CONTRACT NUMBER: CON26-0063
CONTRACT TITLE: VETERANS MEMORIAL PARK EXPANSION
ADDENDUM NUMBER.: 2
ADDENDUM ISSUE DATE: 2026-MARCH-31

Proponents are advised that Addendum No. **2** to *Contract CON26-0063* is hereby issued by the *Owner*. This addendum shall form part of the *Contract Documents* and is to be read, interpreted and coordinated with all other parts. The following revisions supersede the information contained in the original *Contract Documents* and preceding addendums. The cost of all *Work* herein shall be included in the Unit Prices tendered in the *Schedule of Quantities and Prices*. Bidders are to reference receipt of Addendum #2 in their submission.

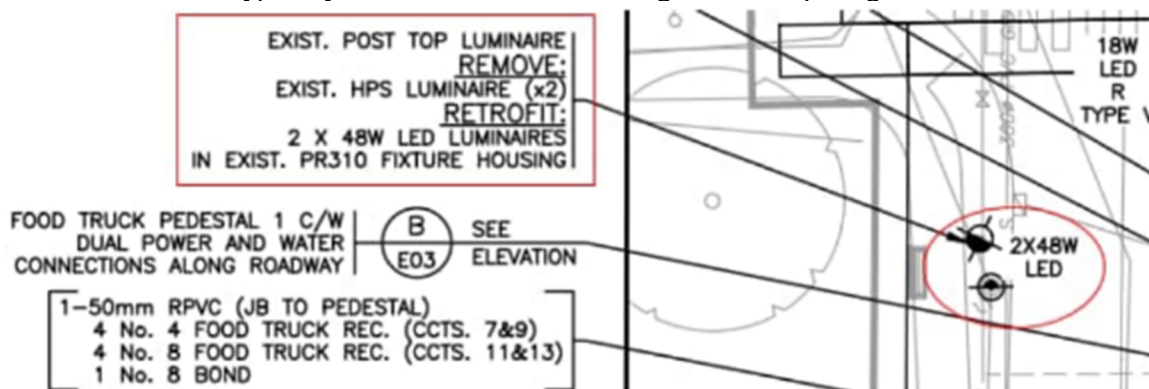
Q47: Will the owner be covering all the bc hydro connection fees also ?

A47: Yes, contractors are to apply for connection with BC Hydro, and the City will be named owner and therefor be charged the fees.
